Biological Sciences B2100 Building Annex
Chabot College

CHANGE ESTIMATE No. 17060.3

BULLETIN 006.1

PHOTO OF EXISTING CONDITIONS- ROOM 2166
VIEW FROM SOUTH LOOKING NORTH

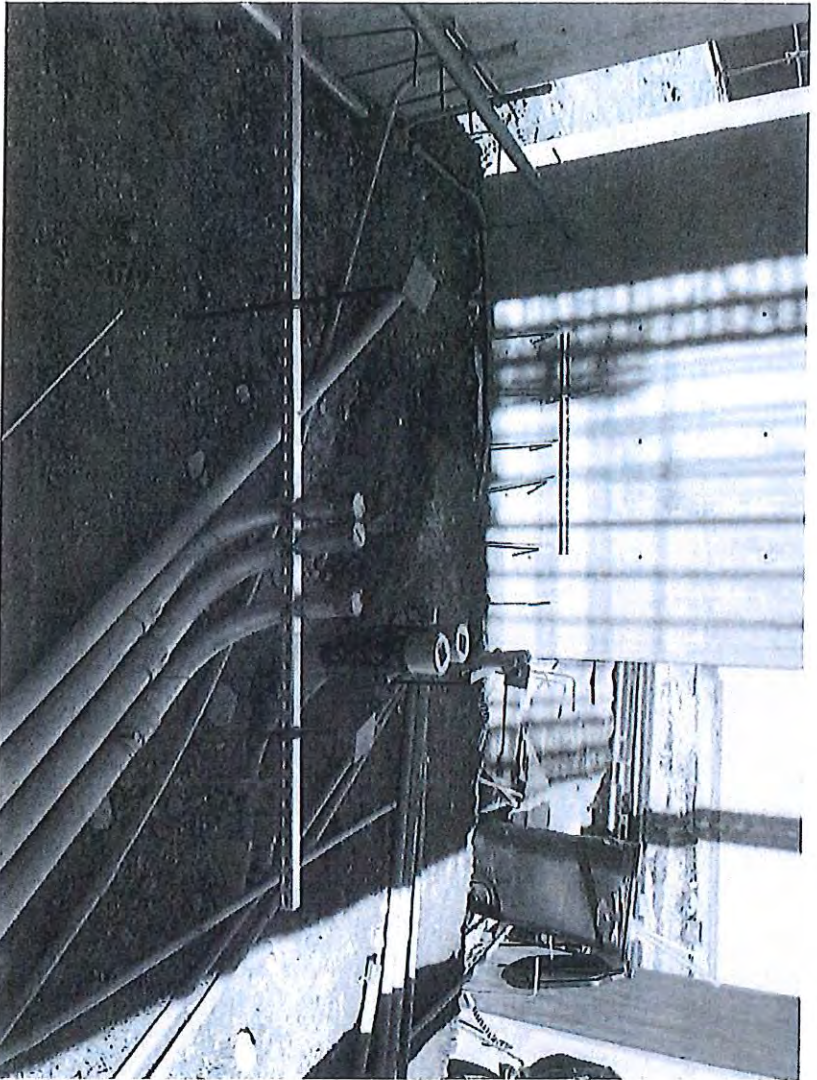
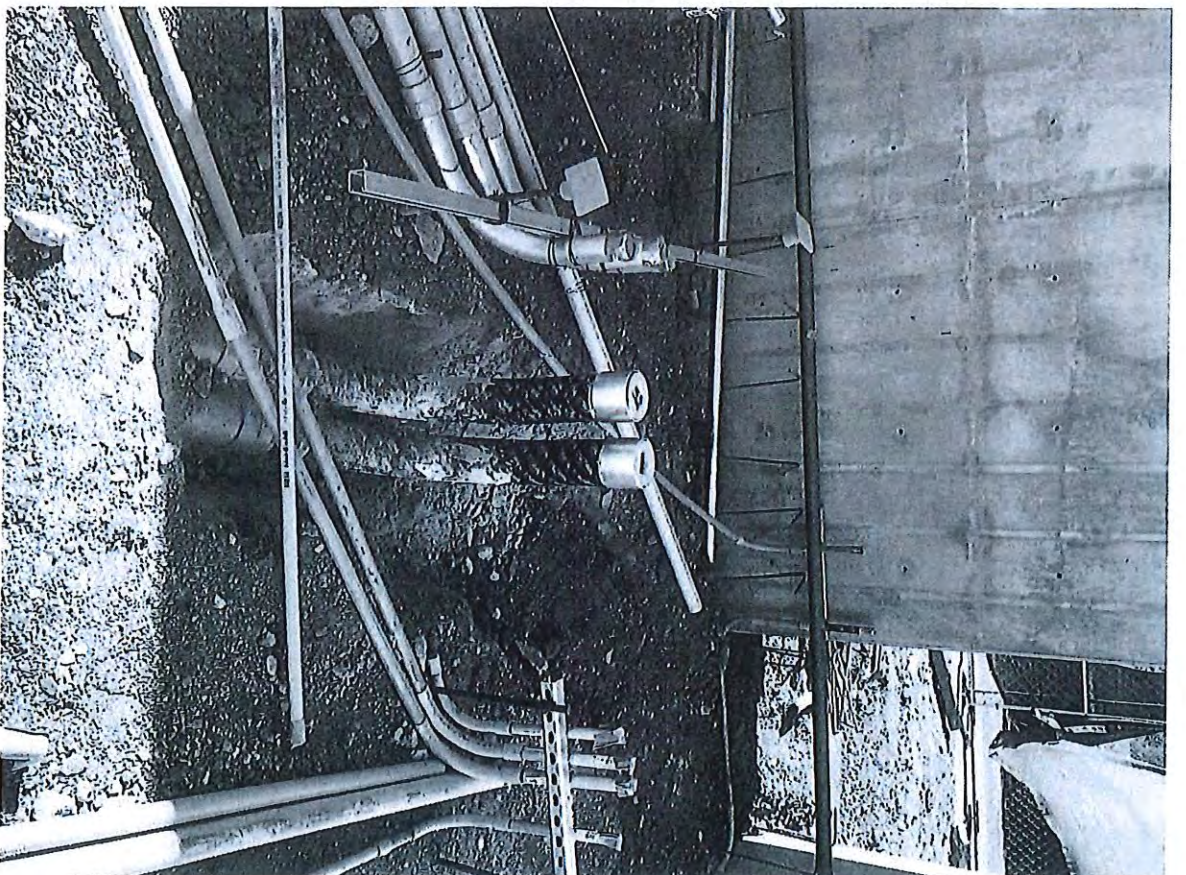
- Revise layout of electric room 2166 per Bulletin 06.1 and 06.1 (REV). Relocate installed conduit to new layout of equipment.

- The original location of the electrical equipment did not provide the code required clearances in front of the equipment.

- Sheet E-103 Electrical- Enlarged Plans: Coordination Drawing, developed during joint meeting with W.A.Thomas, BME Electric, Vanir, HED, Arup, and IOR on 11/7/18 showing layout to accommodate Contractor-submitted electrical equipment. Contractor to coordinate and provide means of anchoring all equipment, including the coordination of penetrating anchors with rebar layout and any conduit run in and/or under concrete slab-on-grade (SOG).
- Photos, dated 11/7/18, of the existing below SOG conditions in the vicinity of Room 2166 (bounded by gridlines A, B, 1 and 2).

1 SECOND FLOOR CEILING FRAMING PLAN

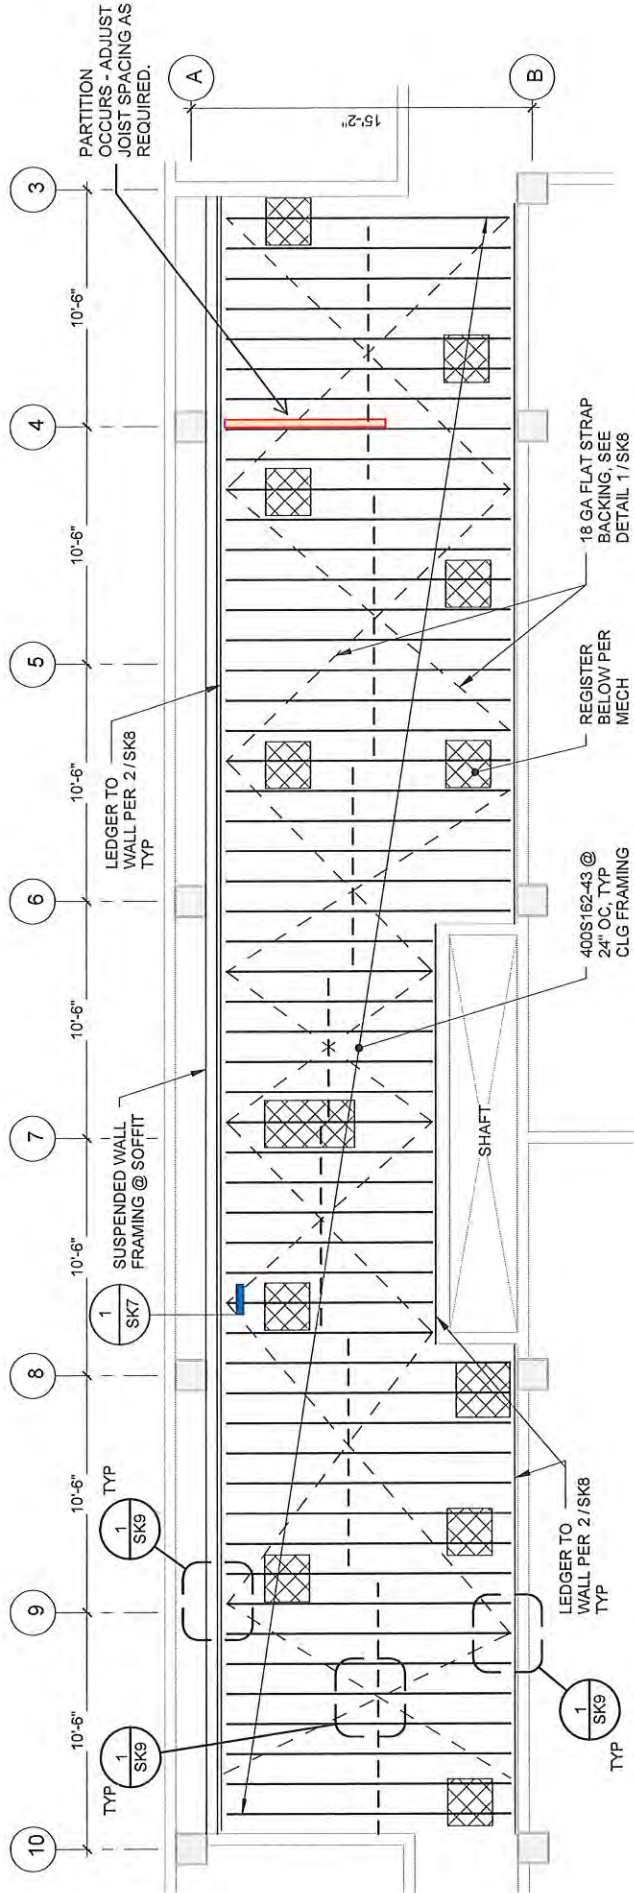
The attached drawing and spec updates are provided to revise ceiling support for back of house areas on second floor of the reference project.

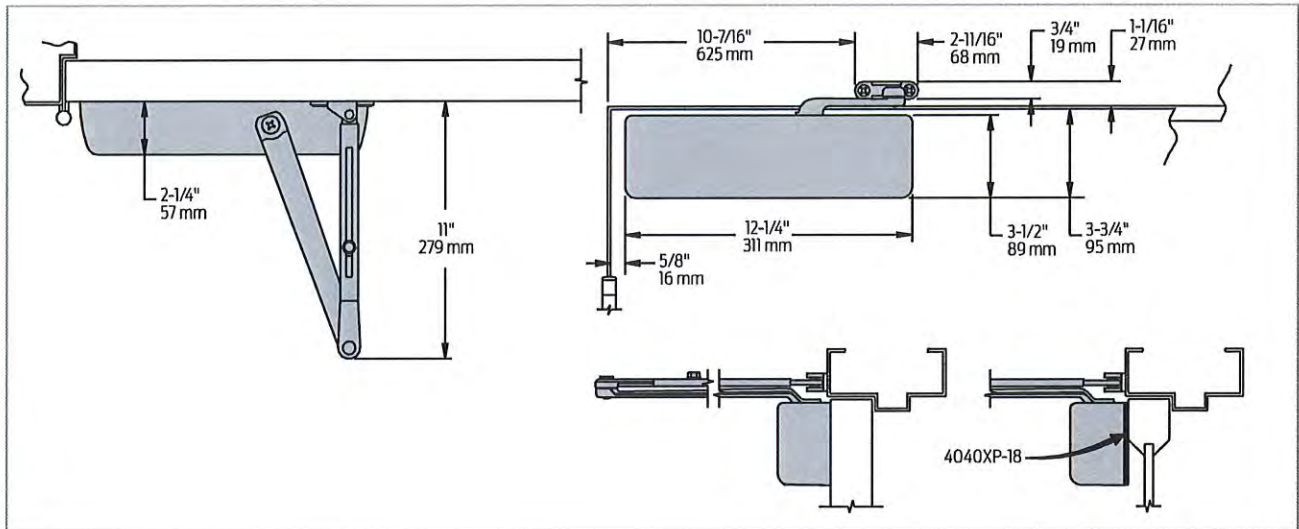
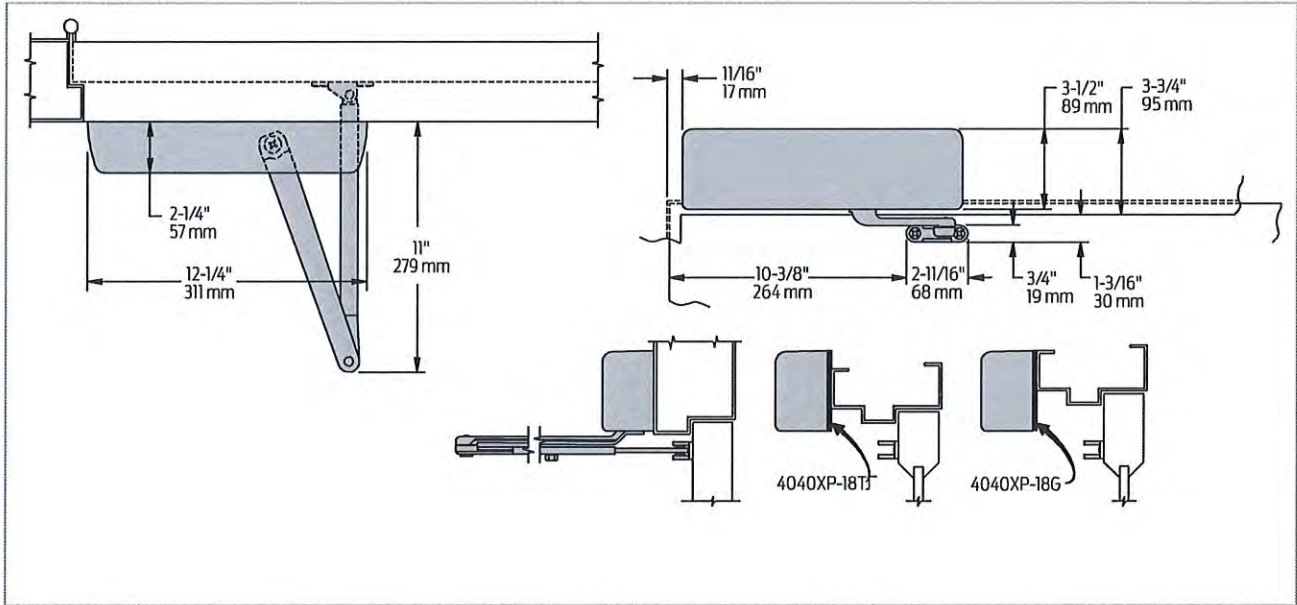
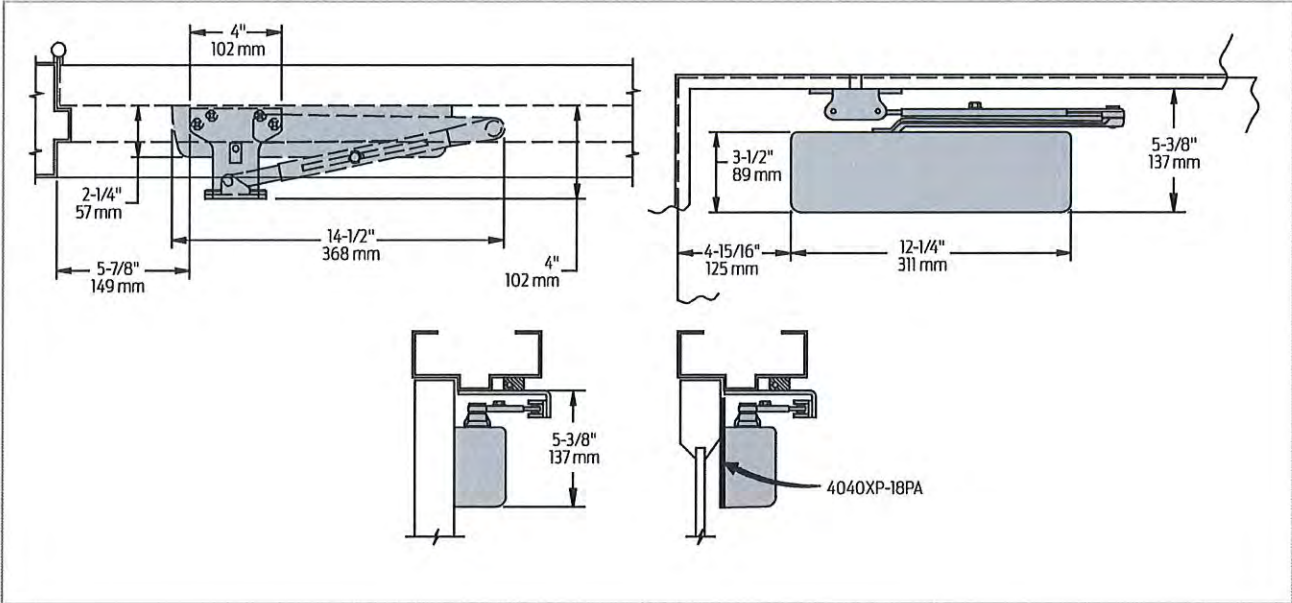
Info.Reg: Please see item #13 in RFD's lab Plumbing punch list. RFD's lab plumbing punch list suggests a door stop for door 2153D. This door is covered under hardware group #23. Hardware group #23 does not provide for a door stop. Due to the location of this door an overhead stop may be required. Please advise.

RESPONSE: Since the door closer is push-side mounted, the simplest solution is to replace the door closer arm with a LCN SCUSH (Spring Cush-n-Stop) arm. See attached product data and Installation Instructions.

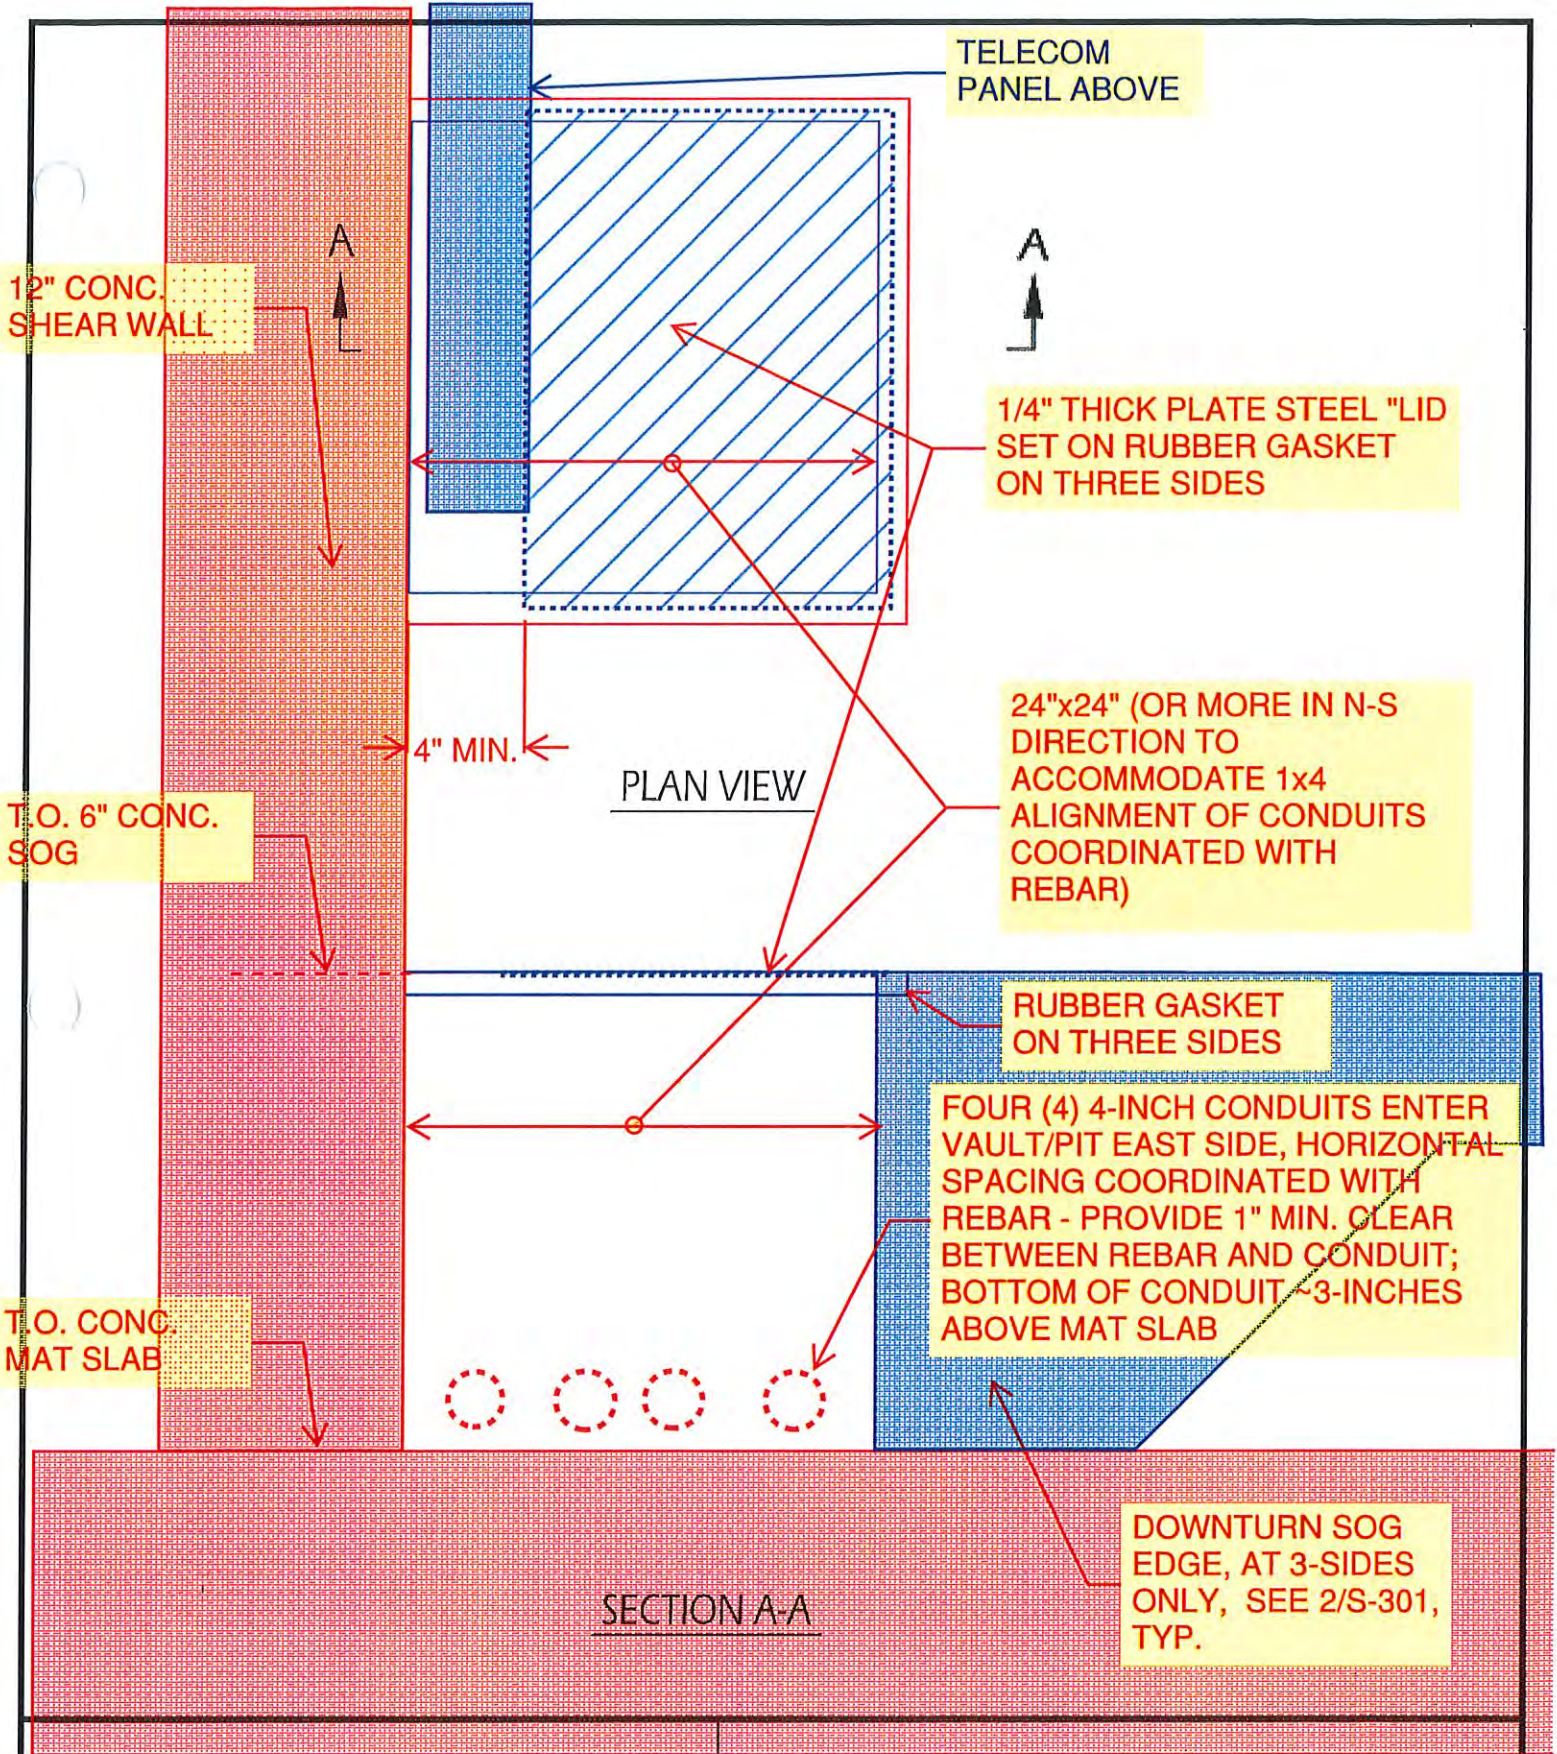
Please see attached BME RFI 3 dated 7/30/18: 1. There is a total of (6) 4" Underground Conduits going into Main Electrical Room on the First Floor. There is also a large pad foundation location underneath this room. From Top of Footing to Finish Floor is 24". We will need to install standard radius 90 fittings in order to accommodate this.

- a. Please verify that we will be allowed to use standard radius 90 fittings
- b. Please verify 24" Cover for these conduits will be allowed under slab.

RESPONSE: THE FOUR (4) TELECOM CONDUITS AND TWO (2) ELECTRICAL CONDUITS ARE TO BE ROUTED PER THE ATTACHED MARK-UP OF SKETCH 01 (PAGE 3 OF THIS PDF). THE FOUR (4) 4-INCH CONDUITS SERVING THE IDF ROOM 2168 WILL FOLLOW THE DIAGRAMMED ROUTE AND ENTER THE VAULT/PIT'S WEST SIDE IN A 1x4 HORIZONTAL ALIGNMENT. SEE ATTACHED VAULT/PIT SECTION (PAGE 5 OF THIS PDF) FOR ADDITIONAL INFORMATION.

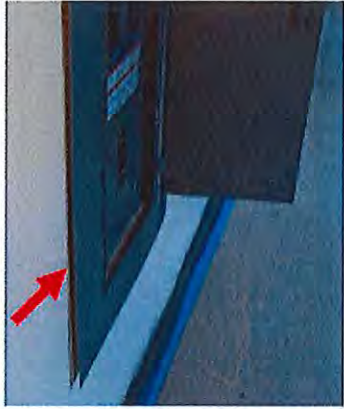
Regarding Item 129 in RFD Field Observation Report (site visit date 9/30/2021) (see image below), the CM notes that these Electrical panels are located in a D3 shaft wall. (See below 6" CH Stud Diagram.) With the 1" liner this wall depth is not sufficient for fully recessing the specified panelboards. Would it be acceptable to install backer rod/caulking around the perimeter flange of the electrical panel to fill the "gap"? The caulking can be painted to match the wall color. (The electrical panel has since been painted). Please advise. Thank you.

129	Lab Electrical	12/18/20; Ensure all panelboards are completely secured and flush with adjacent finished surfaces. Gaps are not acceptable. 9/30/21 STATUS: NOT CORRECTED (OPEN ITEM). BME Because of duct work wall is too shallow for panel. Panel is in as deep as possible. Someone need to come up with a fix.	
-----	-------------------	---	--

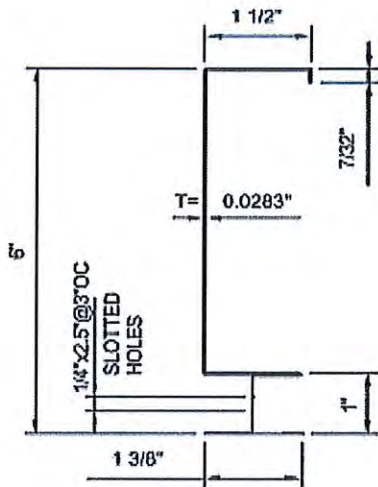
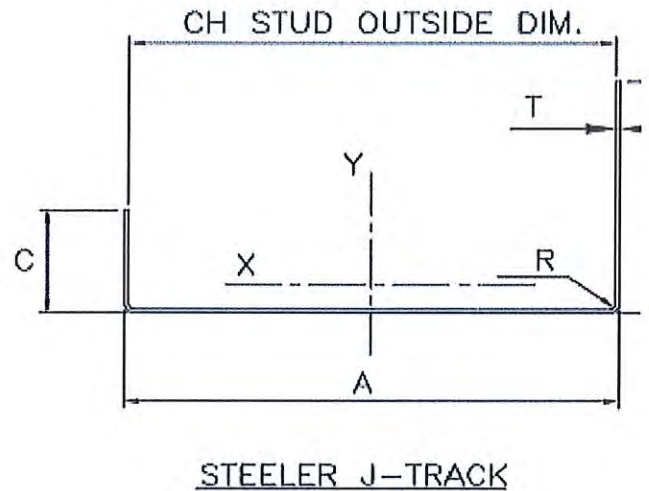
The above FOR notes in item 131 that the electrical panels are to be flush to the finish. These panels are located in a D3 shaft wall. (See below) With the 1" liner this wall depth is not sufficient for the specified panelboards.
